1916 EASTLAKE AVENUE E
RECOMMENDATION MEETING
NOVEMBER 15 2017
SDCI #3023368

EDG SUMMARY & RESPONSE

7 SETBACK BUFFER

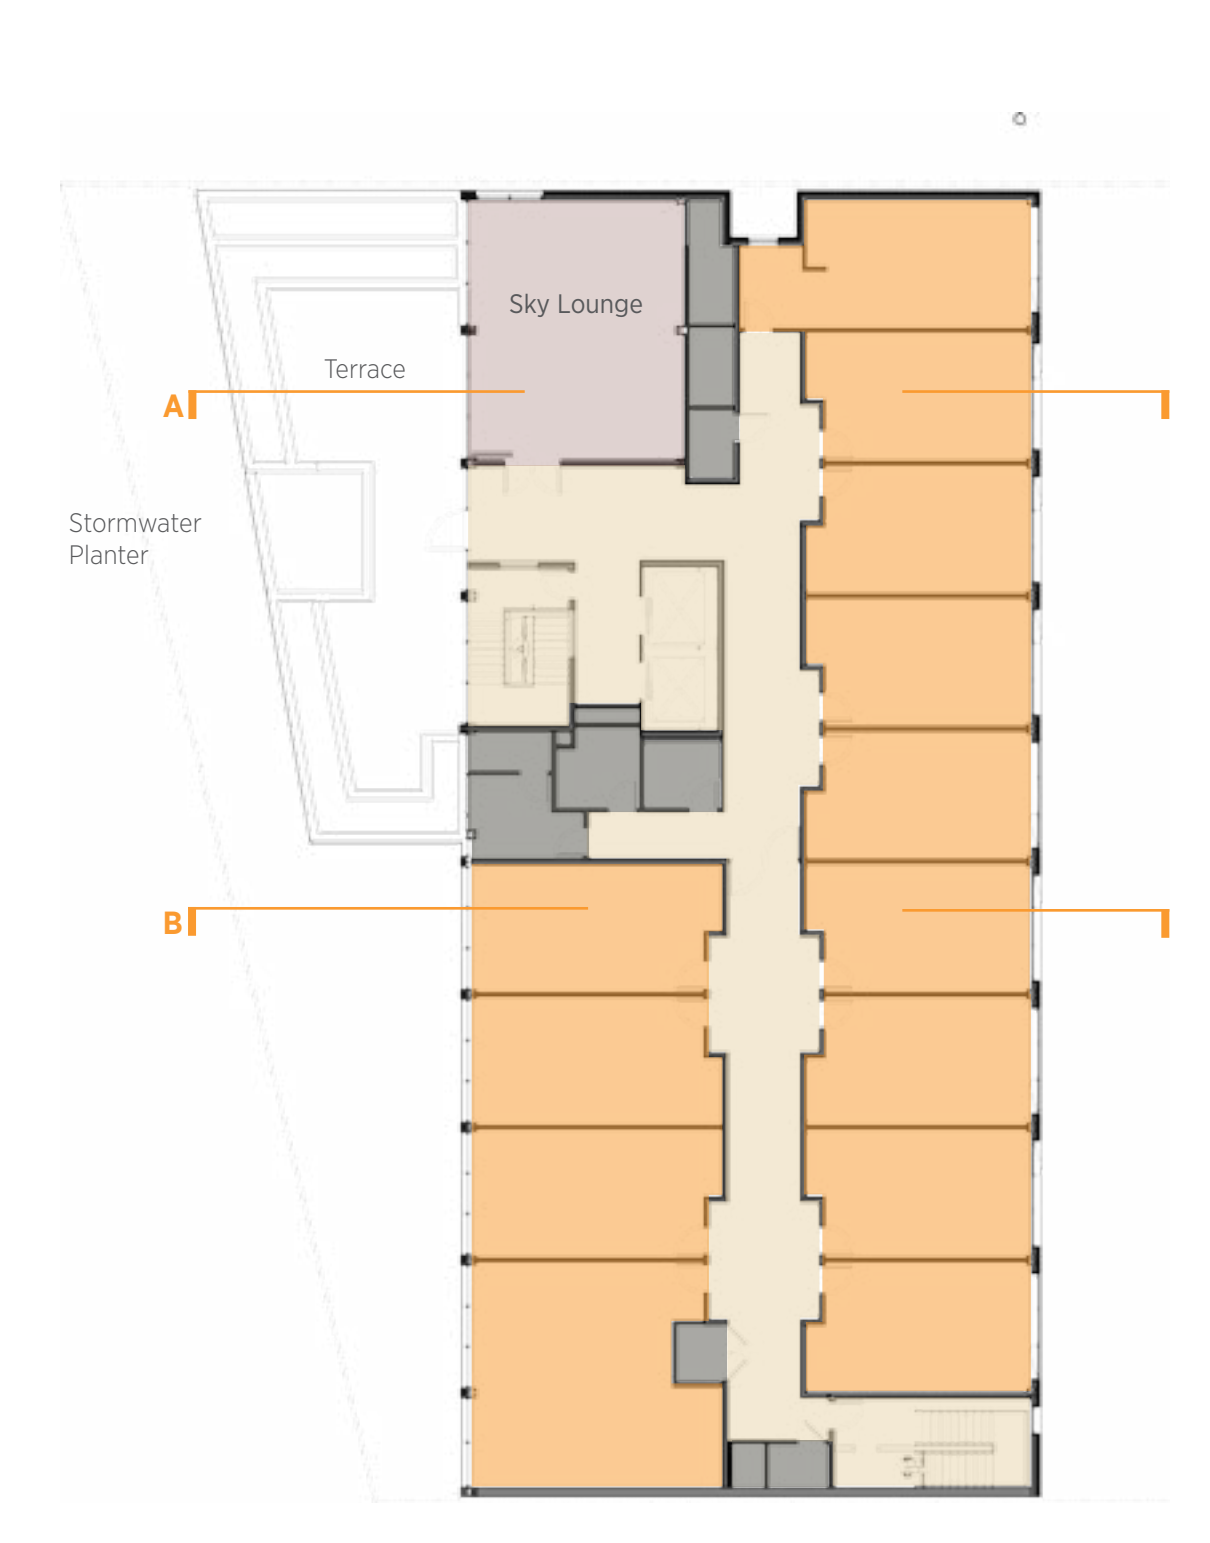
At the Recommendation Meeting the Board would like additional detail demonstrating how the 15-foot setback will be treated to provide a successful transition and buffer between the proposed building and existing residential use. The Board noted that it would be great for the proposed water features to be visible to adjacent uses (CS2-D).

As requested at EDG, additional detail demonstrating the treatment of the east facade and setback buffer are presented in this packet. In addition to maintaining the lowest elevation of the solar array at the east facade adjacent to residential units, the project team has focused on facade composition and detailing to reduce the overall scale of the building. Scale of fenestration and material selection were focused on maintaining residential attributes. Landscaping is integrated to enhance the buffer between properties and minimize privacy impacts.

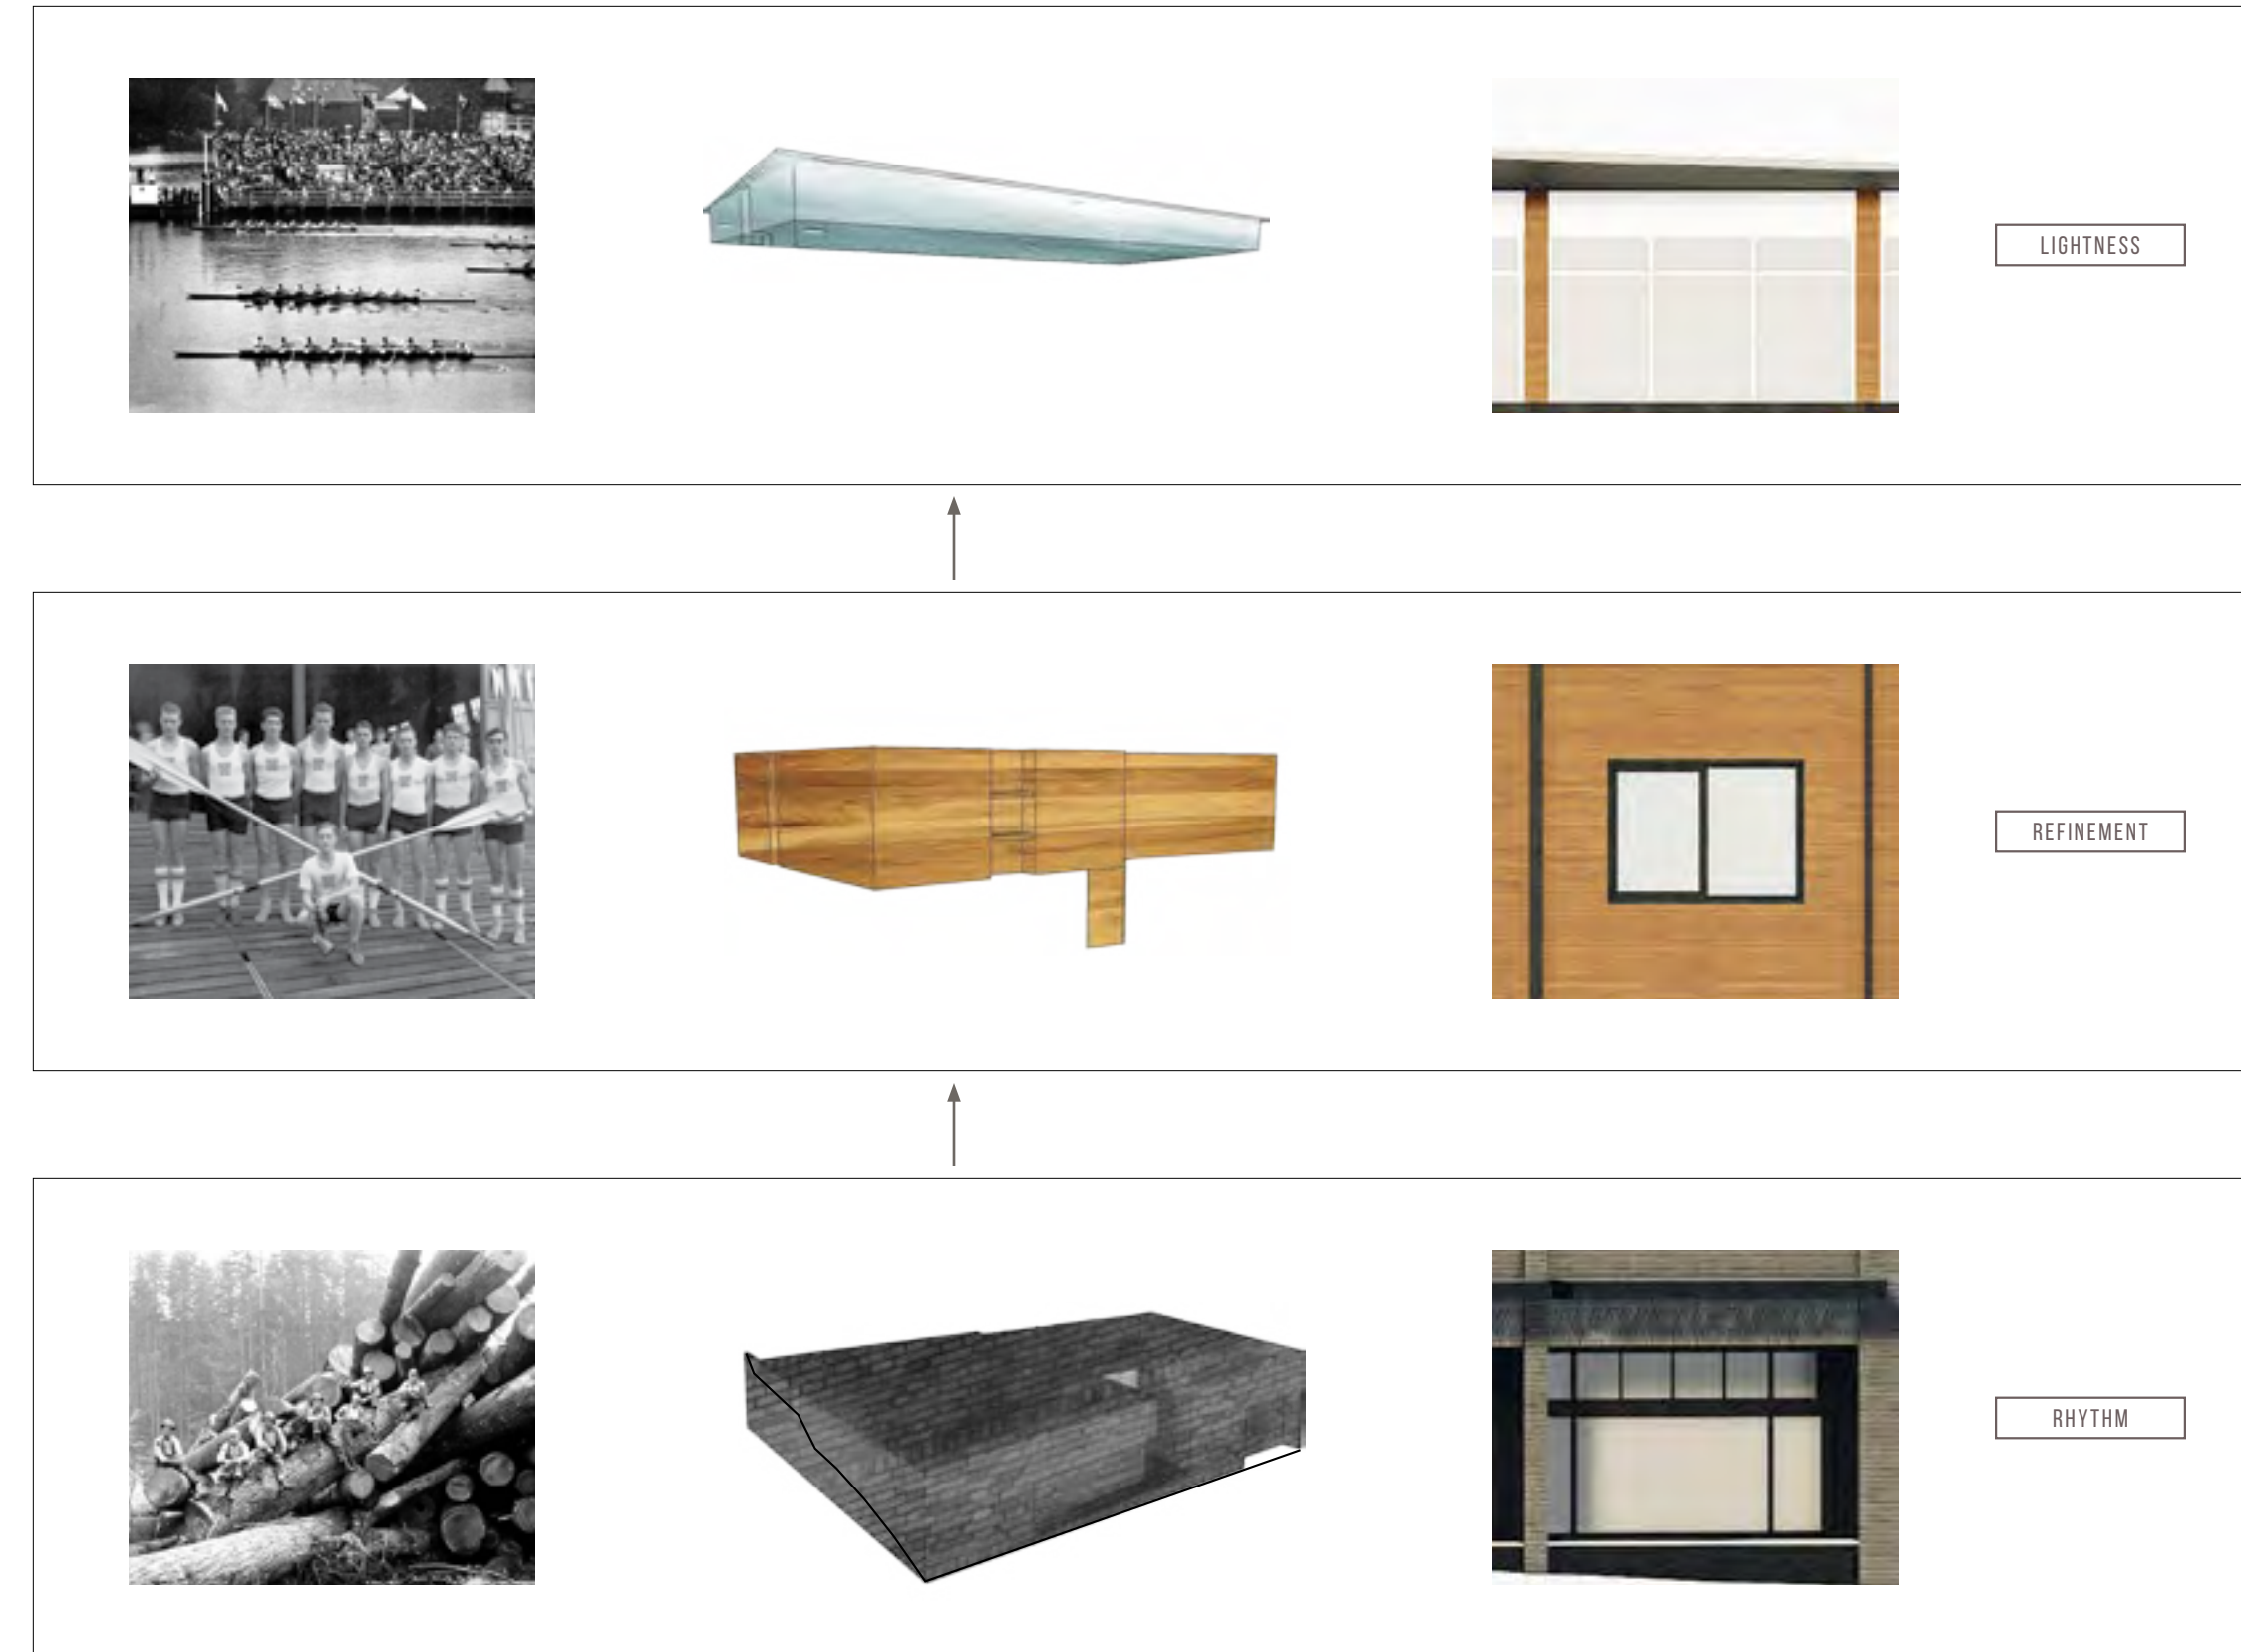
At the Recommendation phase the Board requested fenestration studies demonstrating how the preferred proposal was developed (DC1-A, DC2).
